# Agenda Item #1 - HOLDOVER

## SUB-002723-2023

Divine Mercy Cemetery Subdivision

- Subdivision approval to create two (2) legal lots of record from three (3) metes-and-bounds parcels.

# SITE PLAN

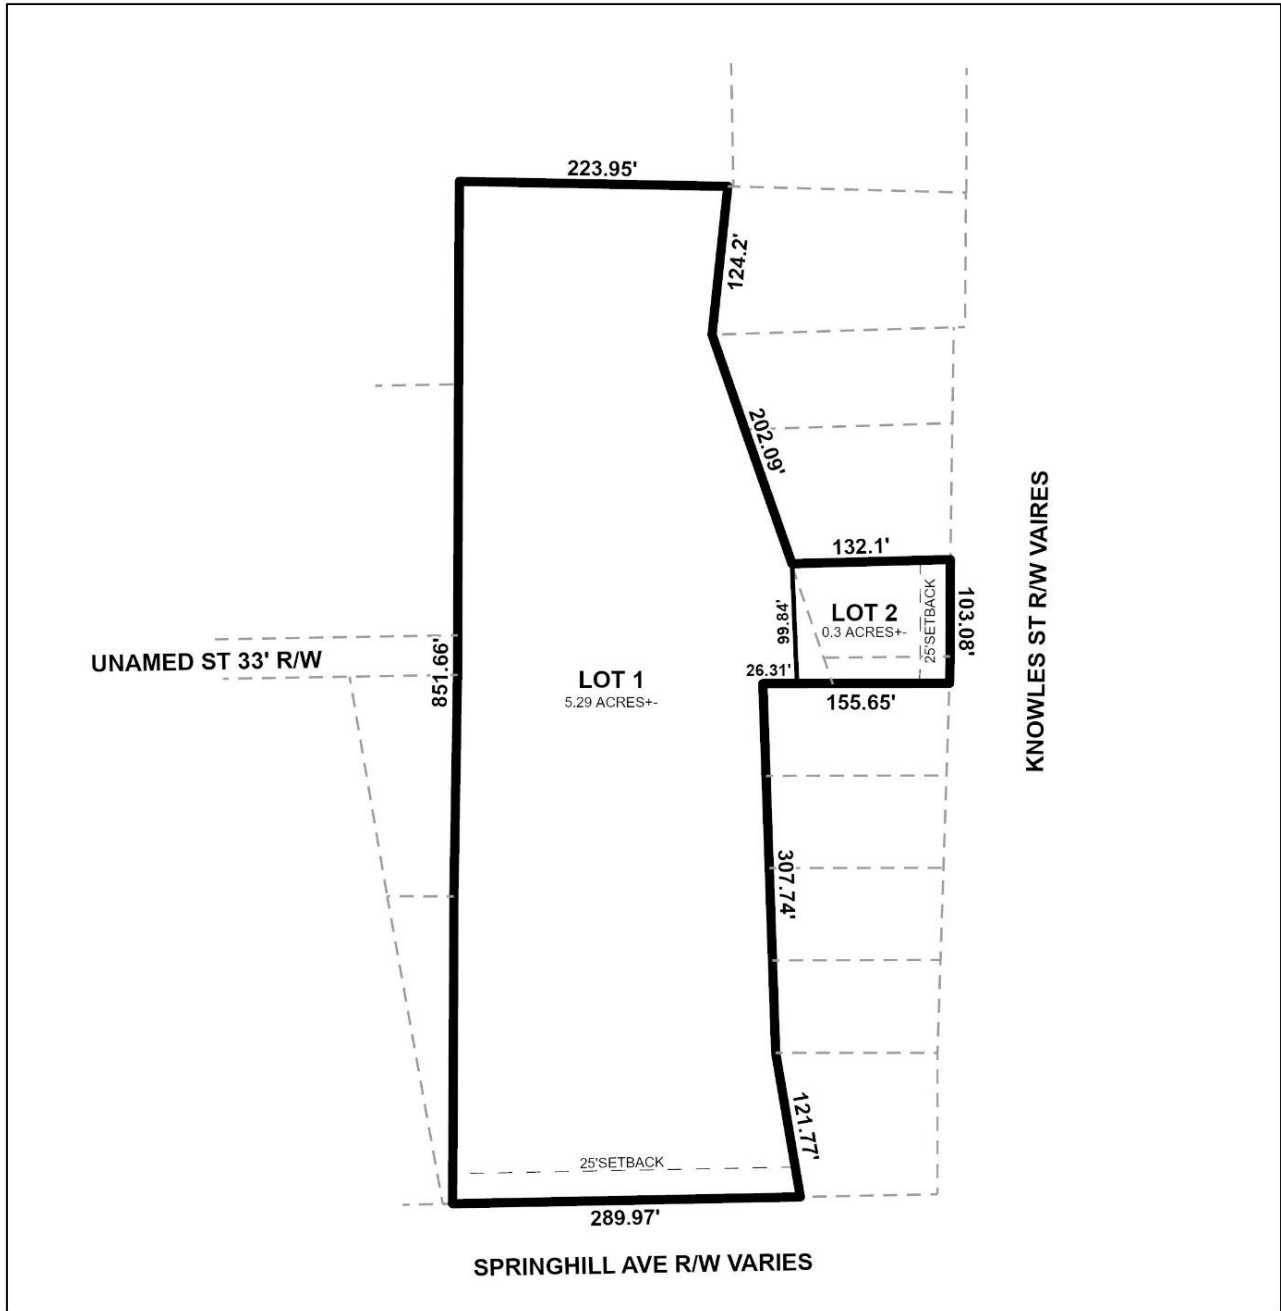
Proposed Lot 1 has frontage along Spring Hill Avenue, a principal arterial street requiring a 100-foot right-of-way, and proposed Lot 2 has frontage along Knowles Street, a minor street without curb and gutter requiring a 60-foot right-of-way. The preliminary plat depicts that the right-of-way varies along both streets at this location. It should be noted that subdivisions (from 1974 and 1983) abutting proposed Lot 2 only required dedication of 25-feet from the centerline of Knowles Street. As such, if approved, a waiver of section 6.B.9. and revision of the plat to illustrate dedication sufficient to provide 25' feet from the centerline of Knowles Street, and 50 feet from the centerline of Spring Hill Avenue, should be required.

It should be noted that the preliminary plat incorrectly identifies Knowles Street as "Knowles Street (Lane)." If approved, Knowles Street should be correctly labeled on the Final Plat.

The lots exceed the minimum size requirement for lots served by public water and sanitary sewer in an R-1, Single-Family Residential Suburban district, and are appropriately labeled in square feet and acres on the preliminary plat. If approved, this information should be retained on the Final Plat, adjusted for dedication; or provision of a table on the Final Plat with the same information, adjusted for dedication, will suffice.

Proposed Lot 1 exceeds the maximum width-to-depth ratio of Section 6.C.3. of the Subdivision Regulations by approximately six (6) feet. Considering the proposed lot's depth is not excessively longer than its width with respect to Section 6.C.3., a waiver of this requirement may be appropriate.

A 25-foot front yard setback is illustrated along Knowles Street and Springhill Avenue, in compliance with Section 64-2-5.E of the Unified Development Code. This information should be retained on the Final Plat, if approved, adjusted for dedication.

1. Revision of the plat to illustrate dedication sufficient to provide 25 feet from the centerline of Knowles Street;
2. Revision of the plat to illustrate dedication sufficient to provide 50 feet from the centerline of Spring Hill Avenue;
3. Revision of the plat to correctly label Knowles Street (and not Knowles Street (Lane));
4. Retention of the lot sizes in both square feet and acre on the Final Plat, or provision of a table on the Final Plat with the same information, adjusted for dedication;

5. Retention of setbacks as shown on the preliminary plat, adjusted for dedication;
6. Compliance with all Engineering comments noted in this staff report;
7. Placement of a note on the Final Plat stating all Traffic Engineering comments noted in this staff report;
8. Compliance with all Urban Forestry comments noted in this staff report; and,
9. Compliance with all Fire Department comments noted in this staff report.
